Access Compliance Report

Public Rights-of-Way

(Curb Ramps)

Intersection ID: 49275	Main Street: GATHERING_CT	Cross Street: REUNION_ST	Location: SE
ADA ID: 49AF60395FC3	Ramp Type: PerpDiag	Initial Pass/Fail: Fail	Overall Compliance: No
Severity Score: 8.75			
Codes/Mitigation Info/Possible Solution		Field Measurements/Component Compliance

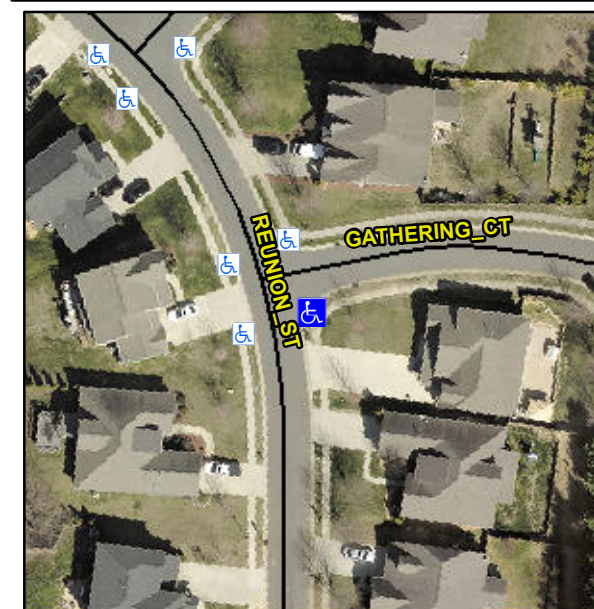
Not Found, R304.5.1

Compliance	Description	Data	Compliance	Description	Data
N/A	Ramp Length (in)	48.5	Yes	Ramp Slope (%)	5.5
No	Ramp Width (in)	46.0	Yes	Ramp XSlope (%)	1.2
N/A	Flare Type LT	N/A	N/A	Flare Type RT	N/A
N/A	Flare Slope LT (%)	N/A	N/A	Flare Slope RT (%)	N/A
N/A	Flare Traversable LT?	N/A	N/A	Flare Traversable RT?	N/A
N/A	Landing Length (in)	N/A	N/A	DWS Provided?	N/A
N/A	Landing Width (in)	N/A	N/A	DWS Contrast?	N/A
N/A	Landing Slope (%)	N/A	N/A	DWS Length (in)	N/A
N/A	Landing X Slope (%)	N/A	N/A	DWS Full Width?	N/A
N/A	Landing Curb? (Y/N)	N/A	N/A	DWS Offset (in)	N/A
N/A	Shared Landing?	N/A			
N/A	Gutter Ponding?	N/A	N/A	Gutter Slope (%)	N/A
N/A	Gutter Lip Ht (in)	N/A	N/A	Gutter X Slope (%)	N/A
N/A	Painted X Walk1?	No	N/A	Painted X Walk2?	No
	X Walk 1 Direction	To N		X Walk 2 Direction	To W
N/A	X Walk 1 Width (in)	N/A	N/A	X Walk 2 Width (in)	N/A
	X Walk 1 Slope (%)	2.5		X Walk 2 Slope (%)	2.1
	X Walk 1 X Slope (%)	1.2		X Walk 2 X Slope (%)	0.1

Remove & Replace Curb Ramp With Two New Directional Ramps or Equivalent.
